# ADDENDUM A Staff Report Z-20-21-4 (Uptown Residential Community PUD)

February 3, 2022

Encanto <u>Village Planning Committee</u> Meeting Date:	September 13, 2021
Planning Commission Hearing Date:	October 7, 2021 November 4, 2021 December 2, 2021 January 6, 2022 February 3, 2022
Request From:	UR TOD-1 (Urban Residential, Transit- Oriented Zoning Overlay One) (4.34 acres)
Request To:	PUD (Planned Unit Development) (4.34 acres)
Proposed Use:	PUD to allow multifamily and single- family attached residential
Location:	Approximately 1,300 feet north of the northeast corner of Central Avenue and Indian School Road
Owner:	Midtown Central Hotel Corporation
Applicant:	Cresleigh Homes Arizona, LLC
Representative:	Norris Design, Alan Beaudoin

FIGURE 5A

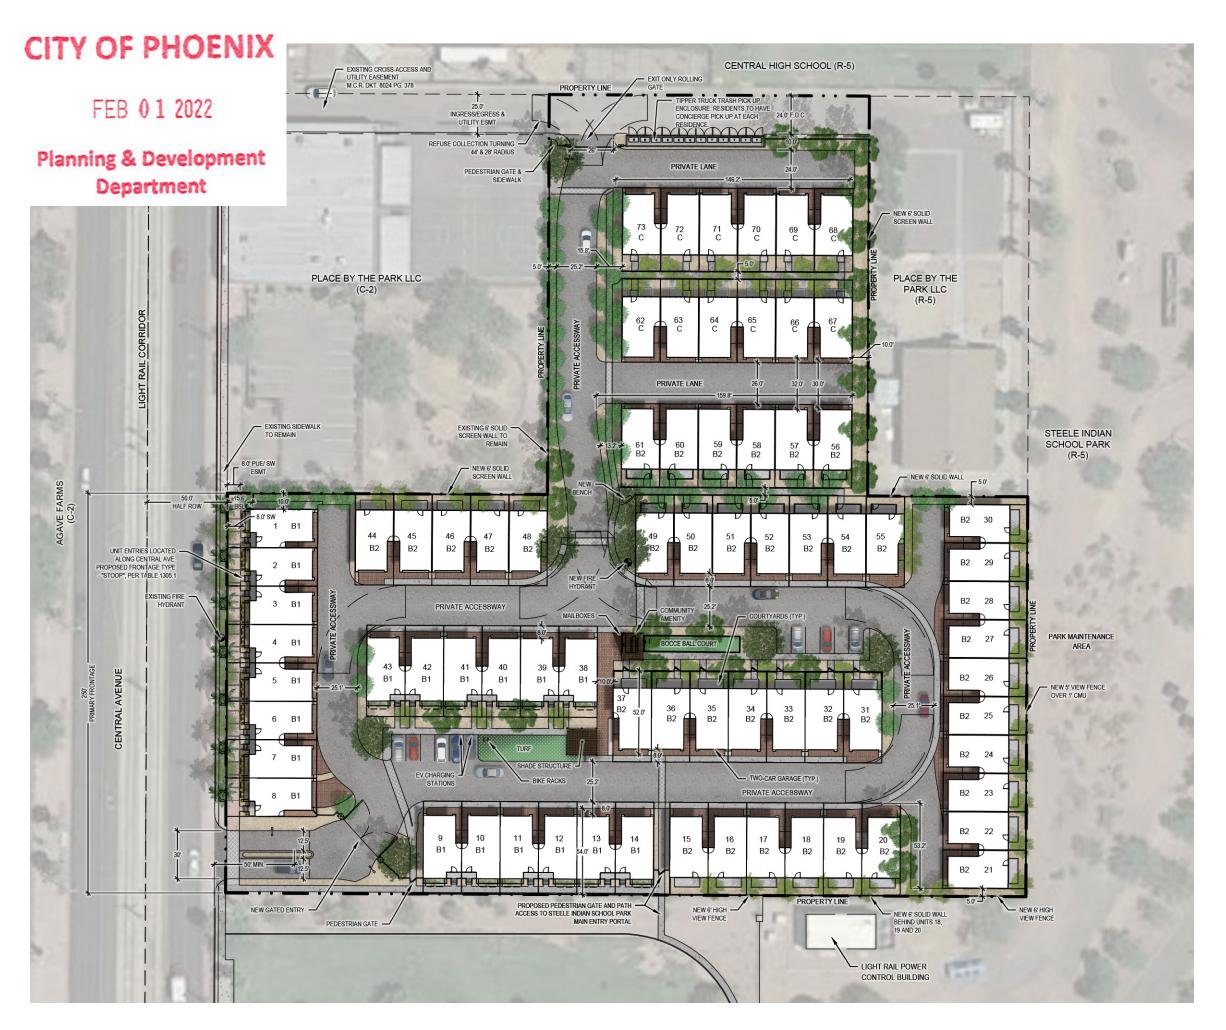
To address the revised frontage types, staff is recommending revised stipulations to reflect the shift from "porch" to "stoop" frontages. Specifically, the revised conceptual site plan depicts Units 1 through 8, adjacent to Central Avenue, and Units 9 through 14, adjacent to Steele Indian School Park and connected to Central Avenue by a pedestrian

pathway. The revised plan necessitates the below stipulations to reflect the proposed changes:

- Stipulation No. 1.a. is revised to require that all dwelling units with a required frontage type be connected to Central Avenue by a direct pedestrian pathway. The purpose of this stipulation is to ensure the south-facing units adjacent to the ungated portion of Steele Indian School Park will be connected to Central Avenue by a sidewalk.
- Stipulation No. 1.g. requires that all units oriented to Central Avenue and several along the ungated portion of Steele Indian School Park include a "stoop" frontage type, specifically Units 1 through 8 and units 9 through 14 as depicted on the Conceptual Site Plan date stamped February 1, 2022.
- Stipulation No. 1.h. through 1.j. to make additional technical corrections pertaining to the shift from "porch" to "stoop" frontage types.

- k. PAGES 9-10, 17, 22, 24, 25, AND 30 34. UPDATE THE FIGURES AND EXHIBITS CONTAINED IN THE NARRATIVE TO BE CONSISTENT WITH THE ILLUSTRATIVE LANDSCAPE PLAN DATE STAMPED FEBRUARY 1, 2022 AND ADD THE ARCHITECTURAL RENDERING FIGURES DATE STAMPED FEBRUARY 1, 2022, TO REFLECT THE CHANGE FROM "PORCH" TO "STOOP" FRONTAGES AND THE ADDED PEDESTRIAN PATHWAY ALONG THE SOUTH PROPERTY LINE.
